ANALOG I/O		
TITLE: vs1005bob11		
Document Number:	1	REV: 1.1
Date: 9/27/2013 14:03:00	Sheet: 2/2

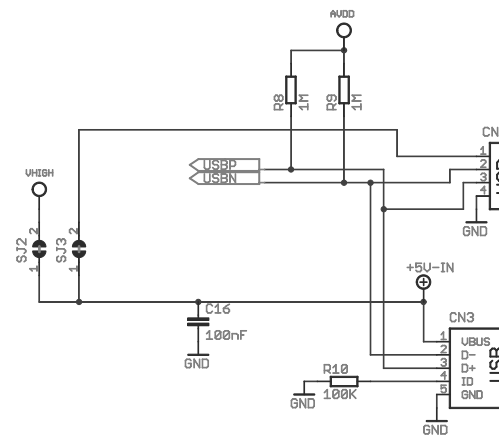
U.1.1  
 - RTC crystal changed to SMD type  
 - USB wiring optimized  
 - GND plane optimized  
 - RS232 Markings on silkscreen
